Description of the differences between the new board and the original board

Reason for change: slight adjustment by the customer with sound and switch to charging IC CL4054H with OVP protection:

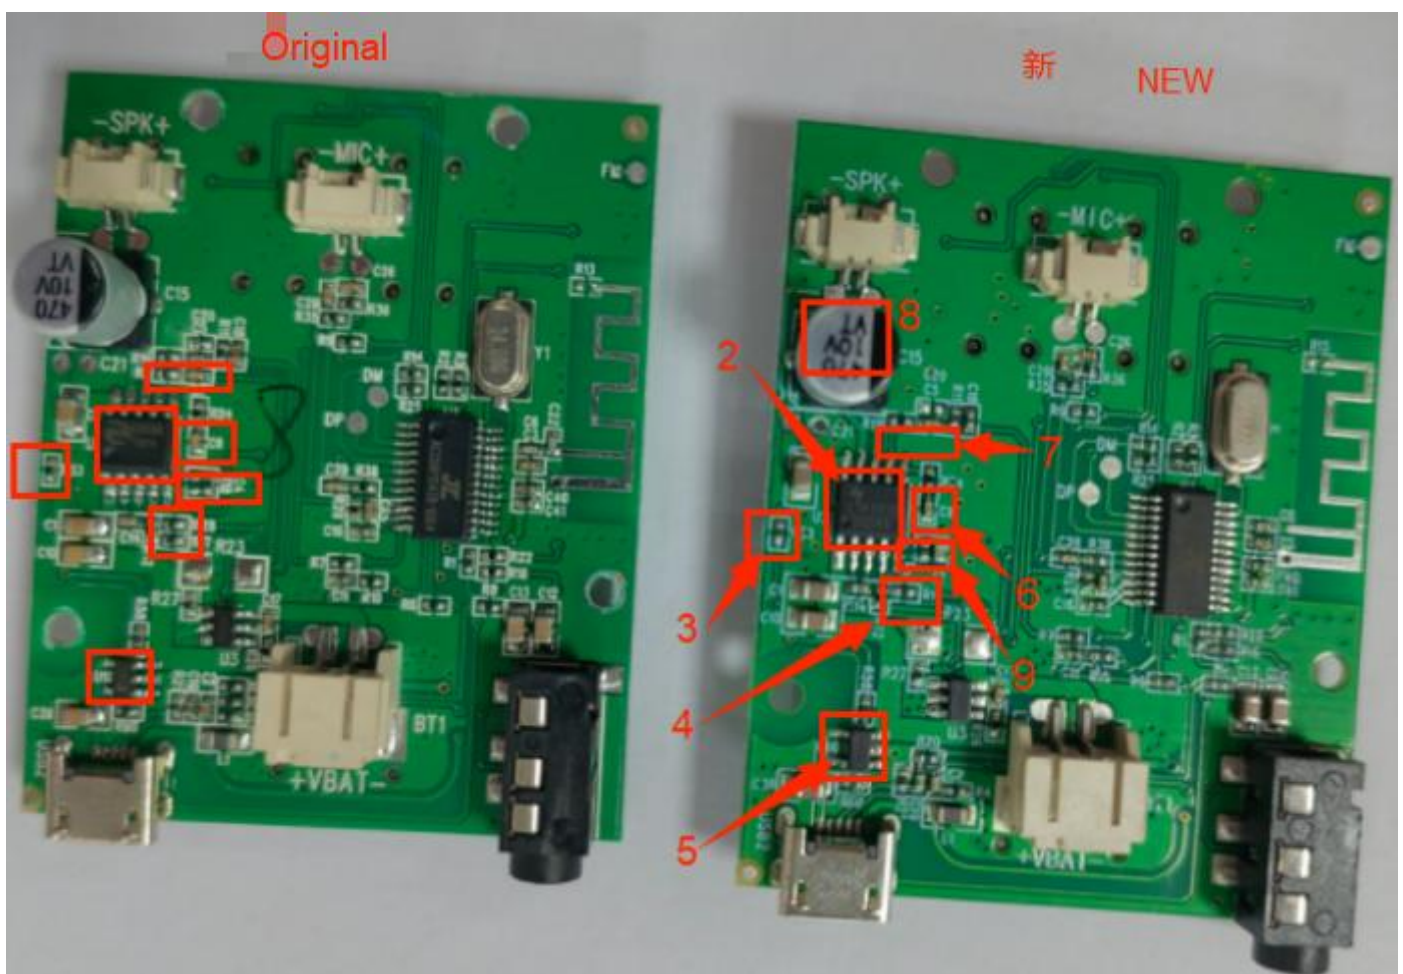
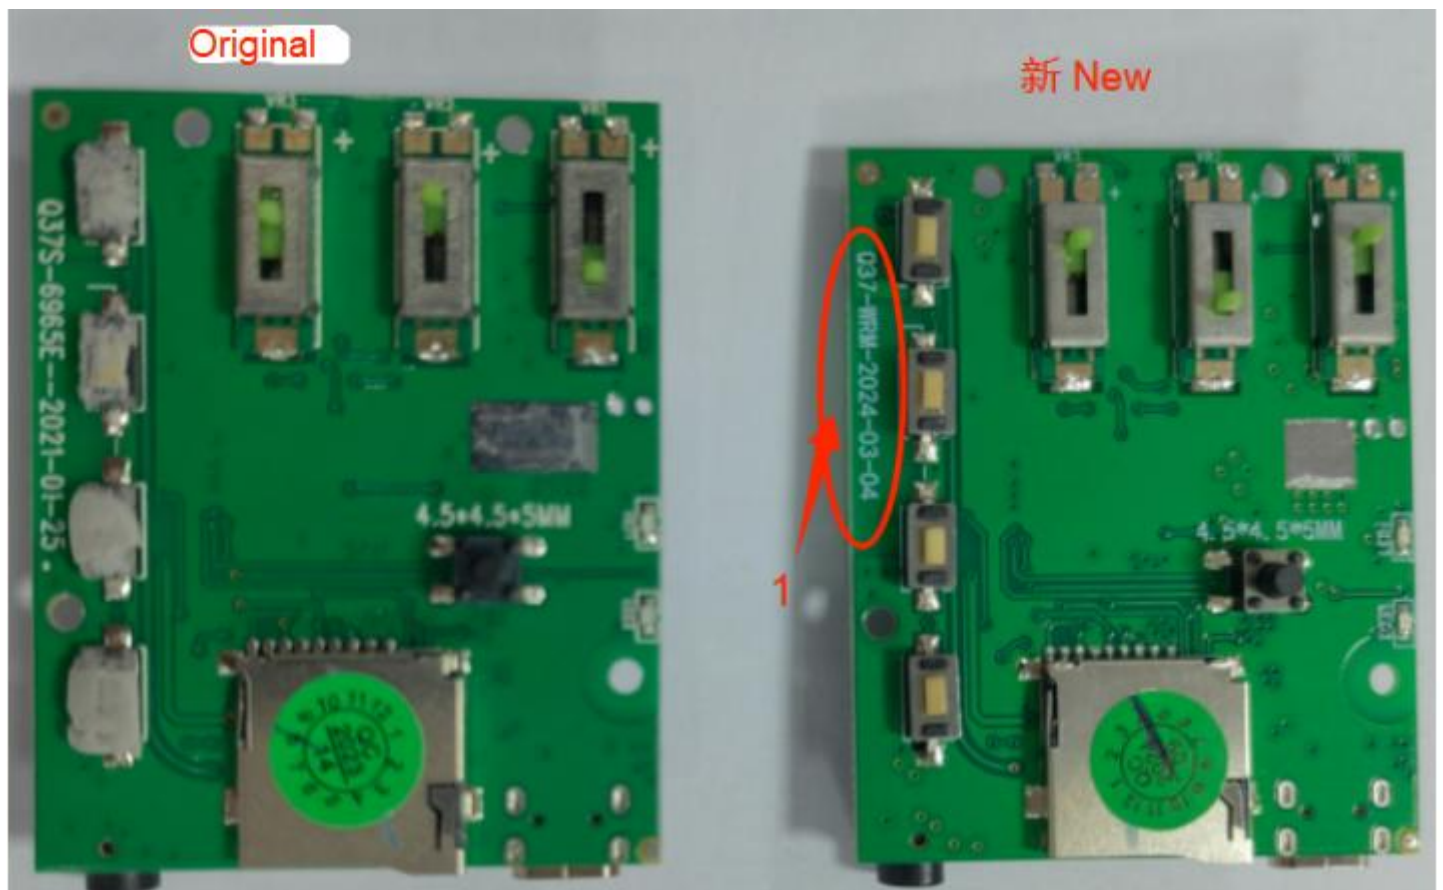
序号 /NO		name	Q37S-6965E (old)	Q37-WRM (new)
1		Silkscreen name/name	Q37S-6965E	Q37-WRM
2	U2	power amplification IC	CS5250	LTK5313
3	R33	Resistor	2.2K	470R
4	R28	Resistor	8.2K	NC
5	U10	charge IC	MX4054	CL4054H
6	C8	capacitor	68NF	47NF
7	R5 C7	Resistor & capacitor	20K , 68NF	NC
8	C15	capacitor	470UF (VT)	470UF (VT / CS /CK) general
9	R18	Resistor	NC	0R
	C4	capacitor	150K	10UF
